Hopwood Hall College

Review of EA Objection Letter – Reference SO/2025/125078/05-L01

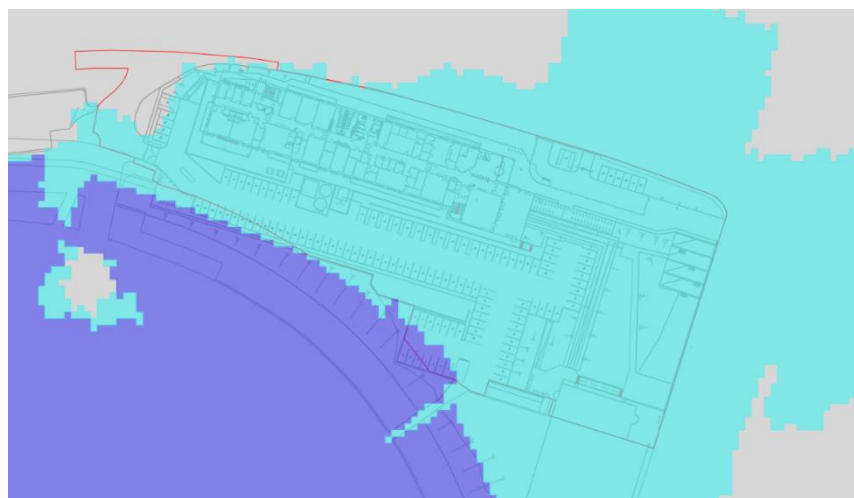
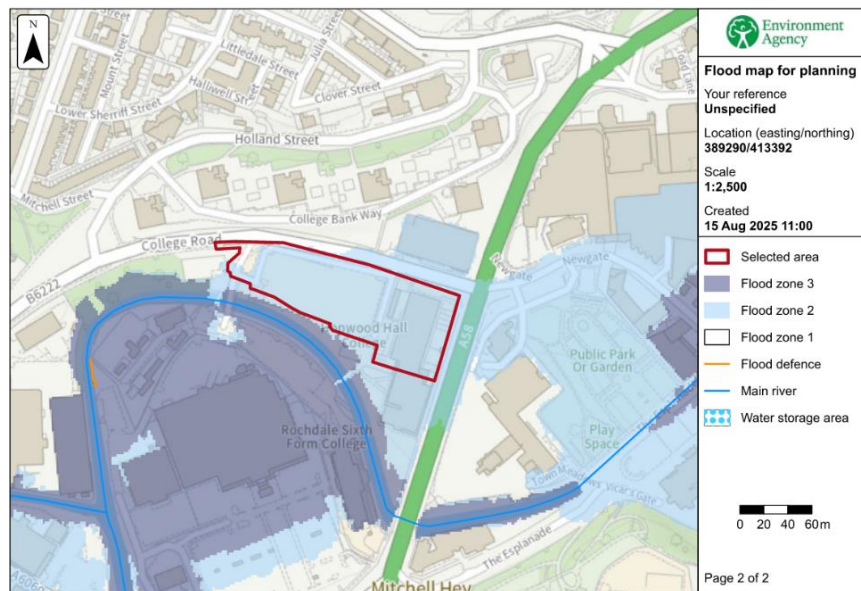
13. Response 1.03 How have we confirmed the development is outside of Flood Zone 3? Have we considered the Product 4 data thoroughly giving consideration to pages 28-35.

Roscoe have confirmed based on governmental flood mapping the development is in Flood Zone 2. Whilst the EA consider, that even though the boundary has changed to be outside of the government flood mapping, the Product 4 data shows flooding within the site for the 100yr + 35cc & 70cc storm events which places the development in Flood Zone 3

WDC Question – EA Response 1.04 Have we confirmed how we have got to this conclusion and why we consider we are in Flood Zone 2?

- Have we correctly interpolated the Product 4 data we have been provided
- Have we requested the velocities from inforequests.gmmc@environment-agency.gov.uk

The site is was determined to be within Flood Zone 2 based on several points.

- 1) The Governmental Flood Mapping Data that is used on all schemes and is recognised as the primary determinations by the EA, show's the site to be within Flood Zone 2.
- 2) Initial Product 4 data received (Product 4 data provided 23rd July 2025), stated maximum flood level at 119.38. Which is 150mm lower than the existing / proposed car park level and so would not indicate any flooding on site, in line with typical Flood Zone 2 or 1 data.
- 3) There is no historic flooding event to have occurred on our development. As per EA Product 4 information.
- 4) The pre-app letter from the local council confirmed the site was in flood zone 2. Please see correspondence letter attached. Roscoe have highlighted where they have stated the site is positioned in flood zone 2- please see page 8 of the document.
